20 RESPONSE TO COMMENTS

The Draft Environmental Impact Report (DEIR) for the Coyote Creek Agrivoltaic Ranch Project (the project) was circulated on March 5, 2025 (State Clearinghouse Number 2022010271) for a public review period that ended on May 5, 2025. A total of 74 individual letters were received during the comment period and one additional letter was received after the close of the public review period. This Final EIR (FEIR) provides responses to comments received on the DEIR. Each letter has been assigned a number, as indicated below.

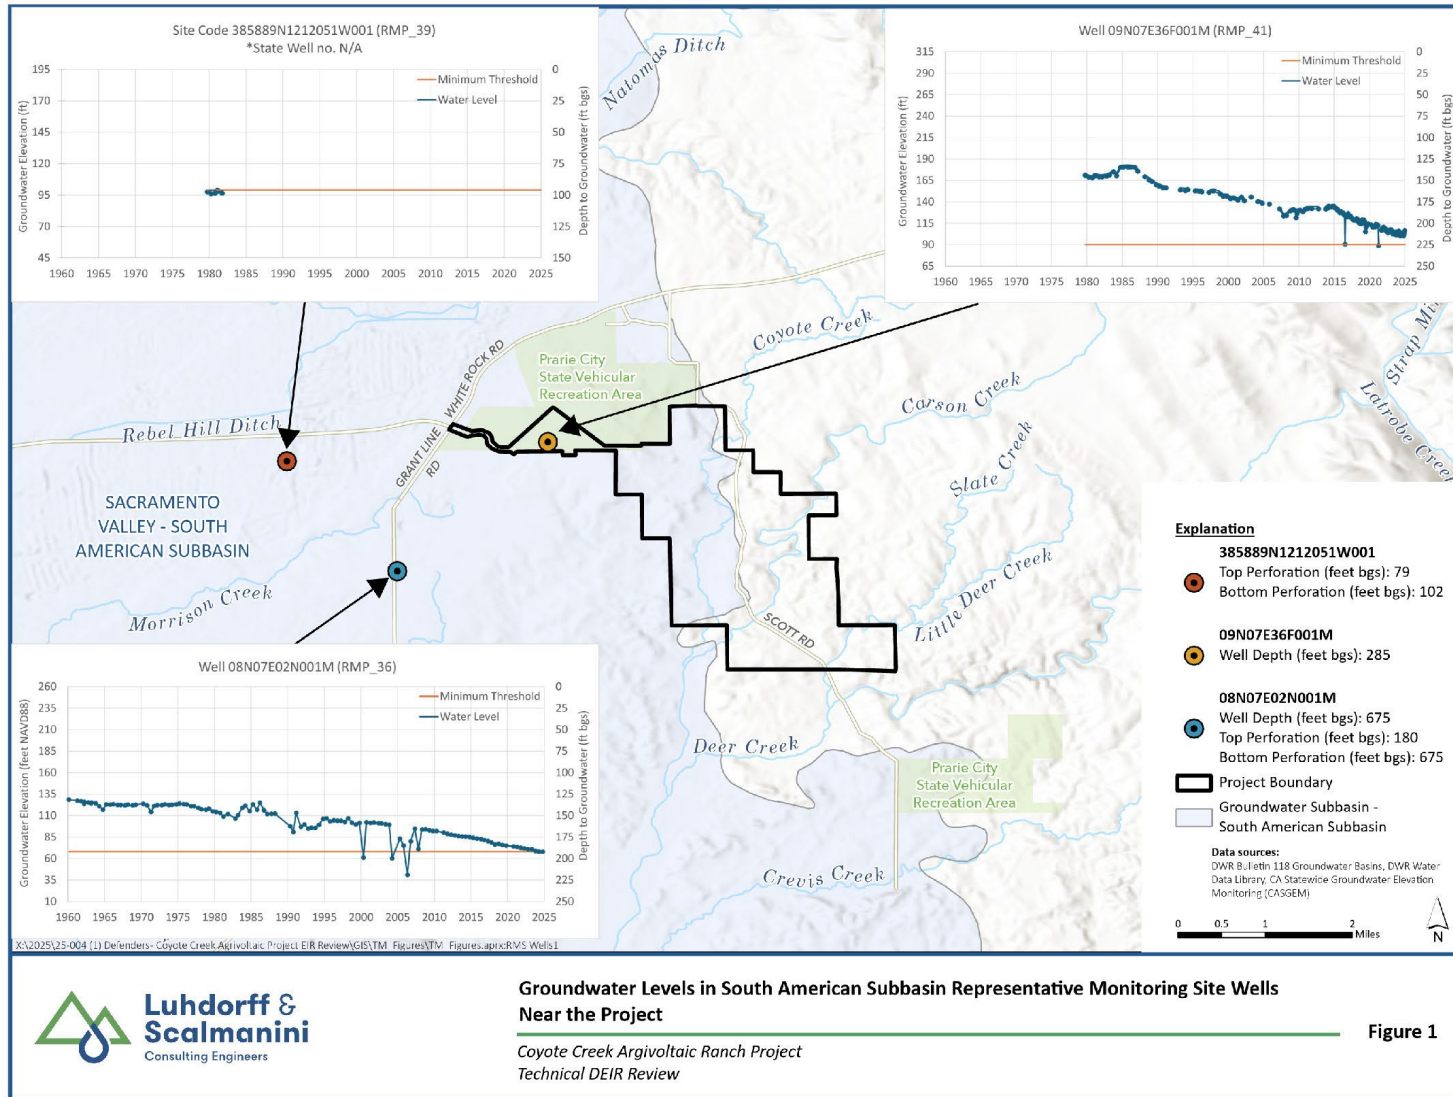
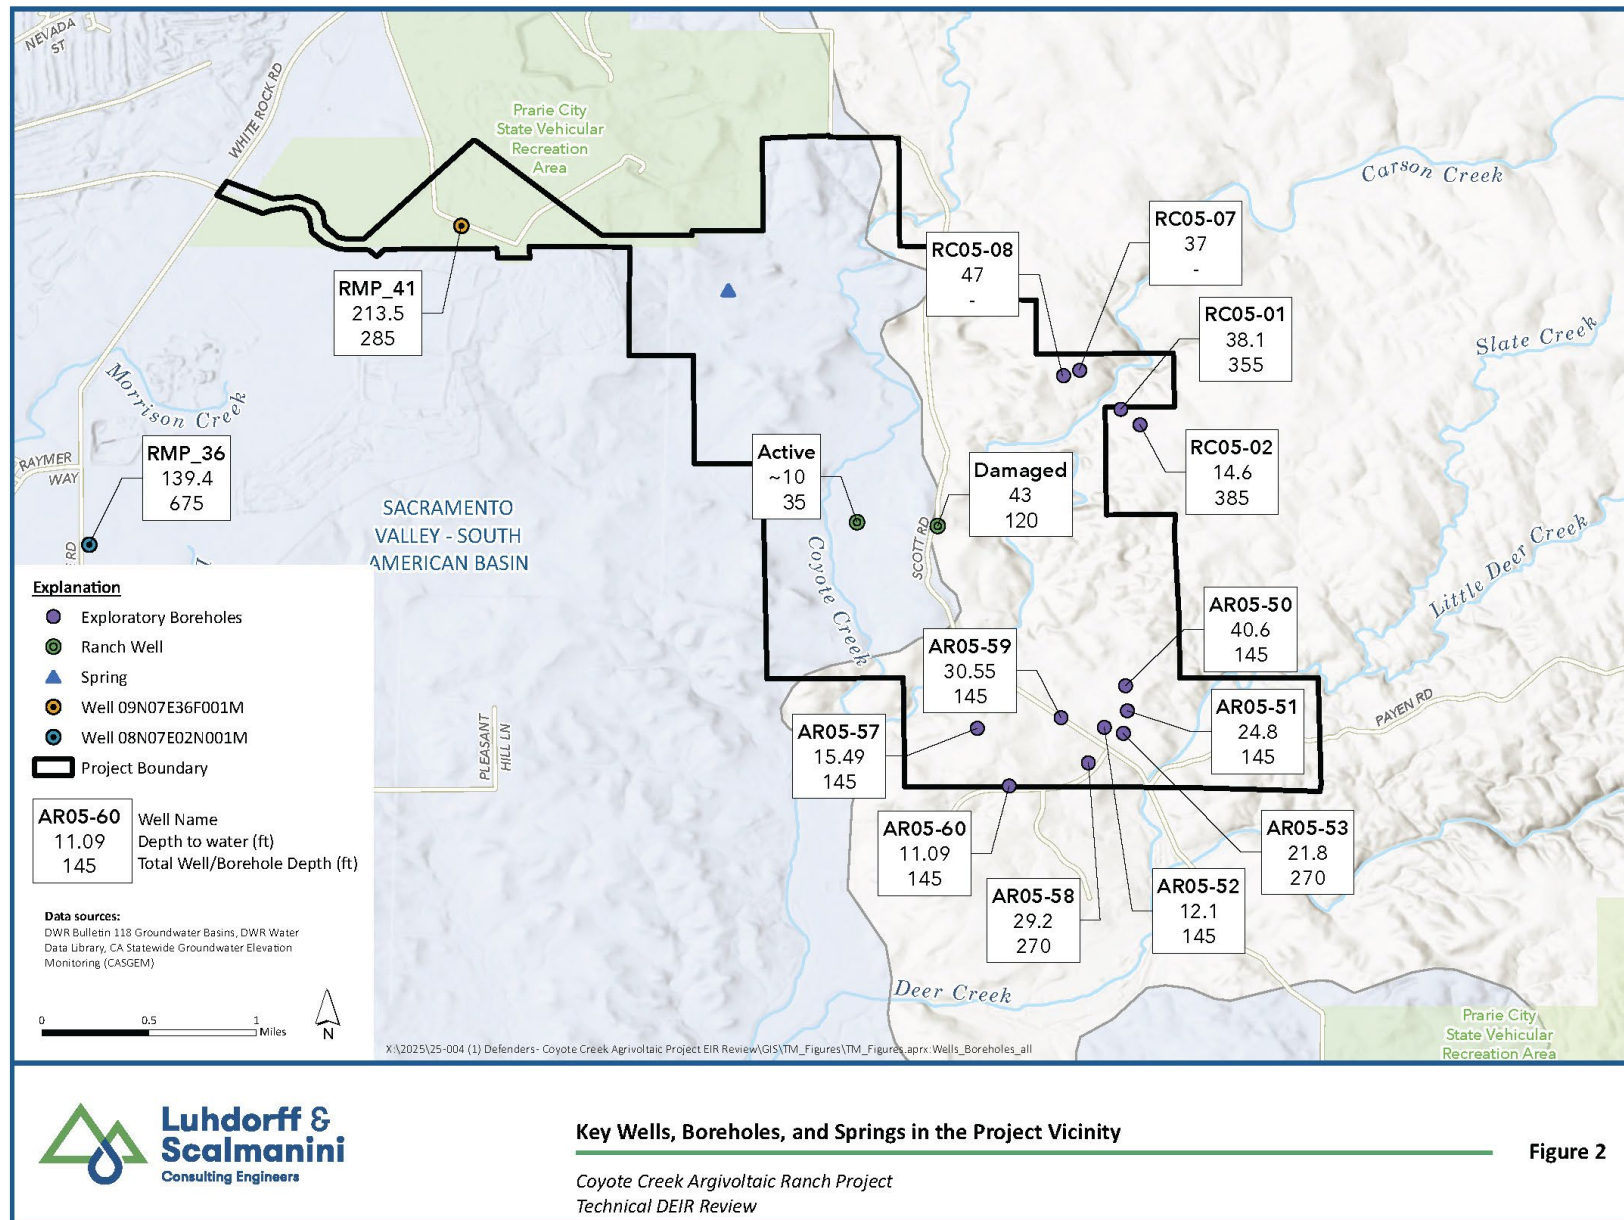
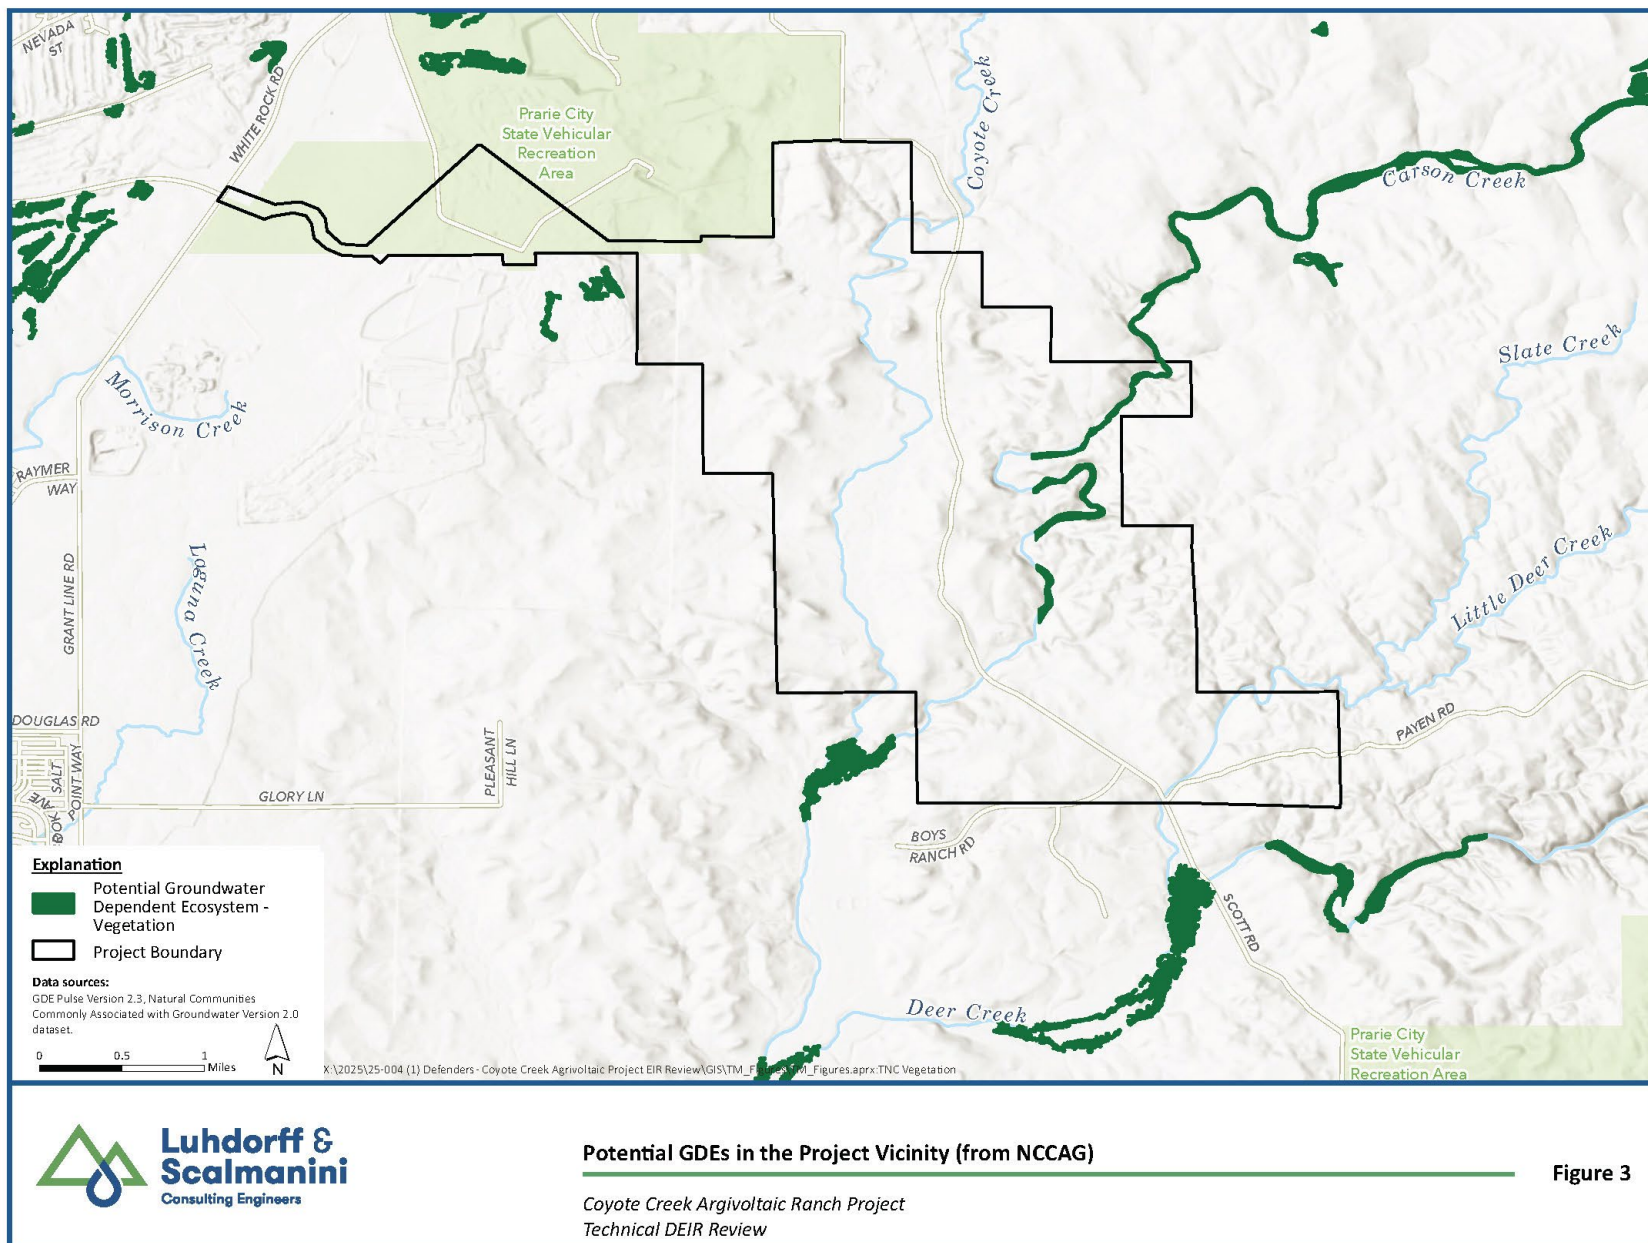
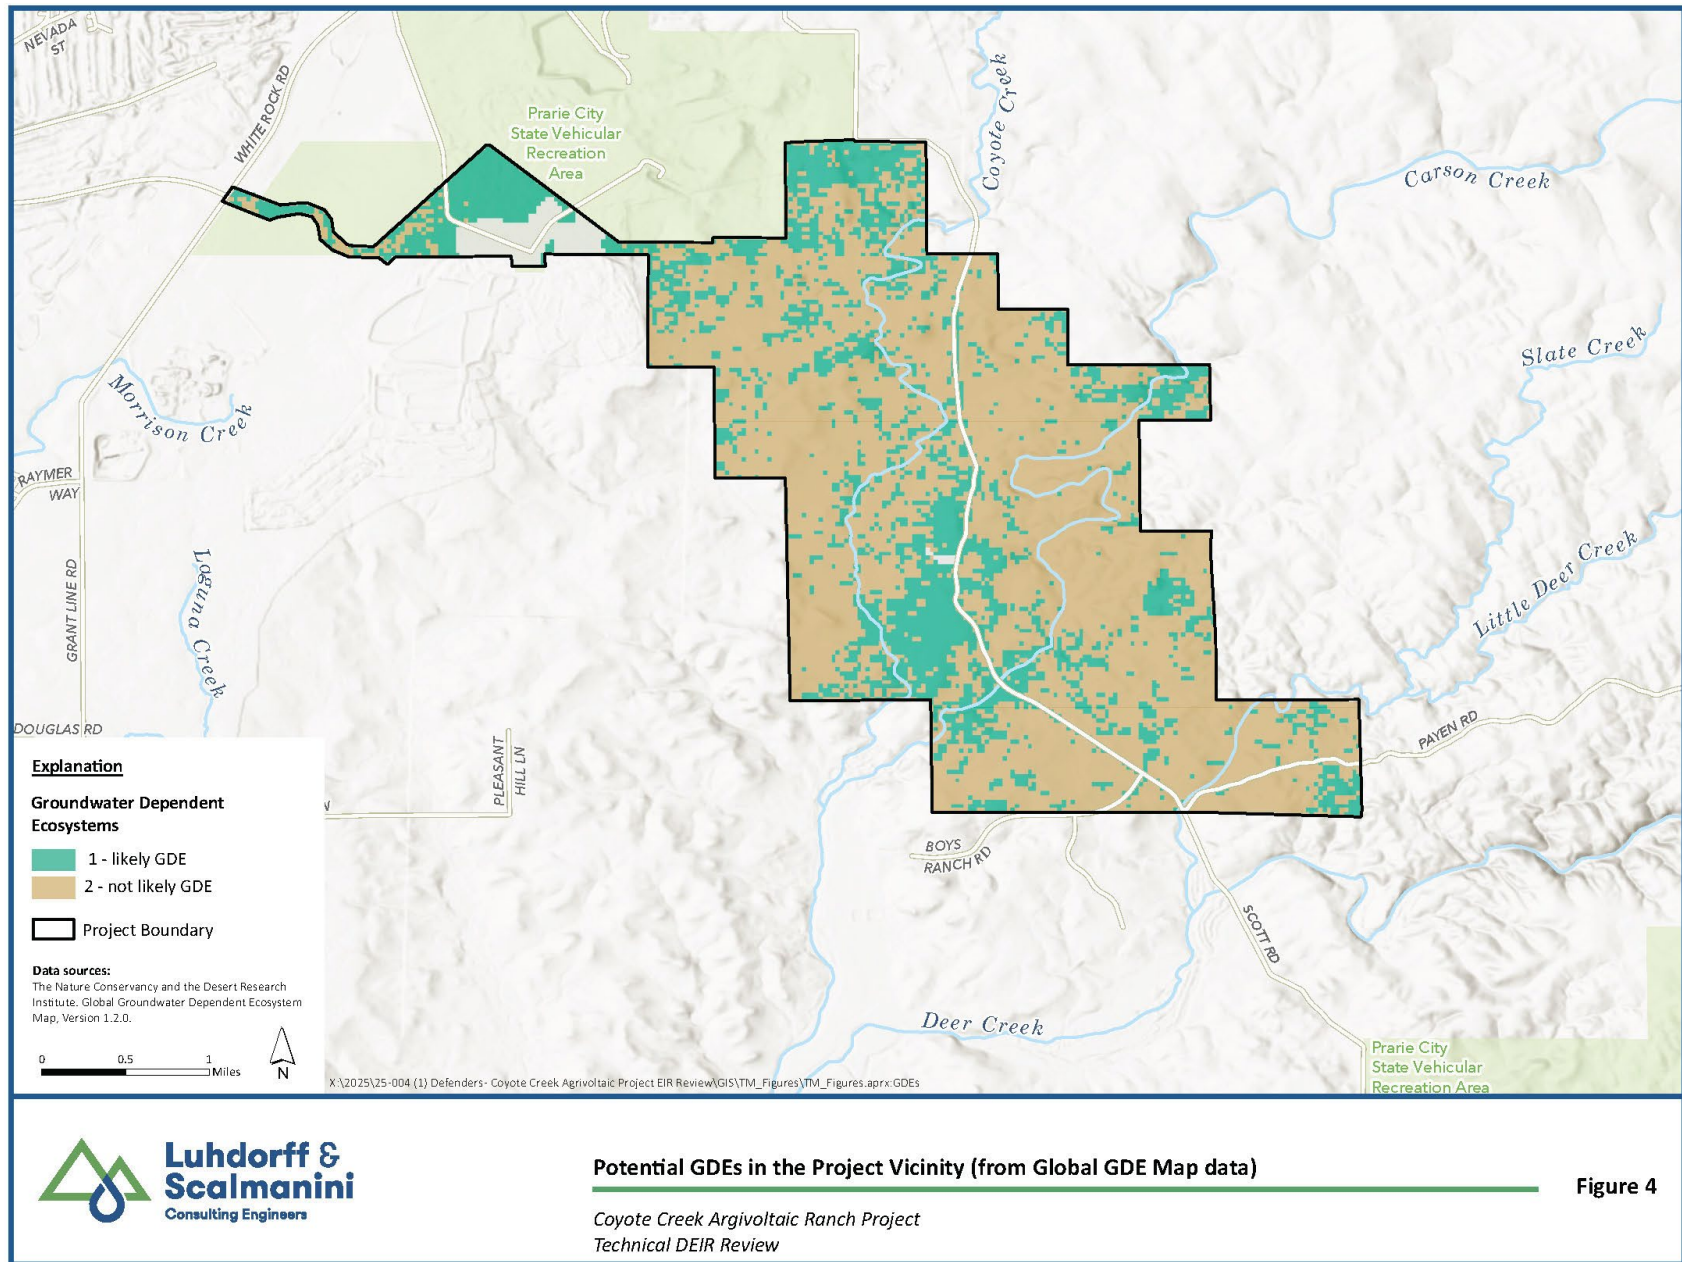
COMMENT 03-286

This comment consists of Figures 1 through 5 attached to the LSCE comment letter. These figures were reviewed and considered by the County in the responses to comments provided above.
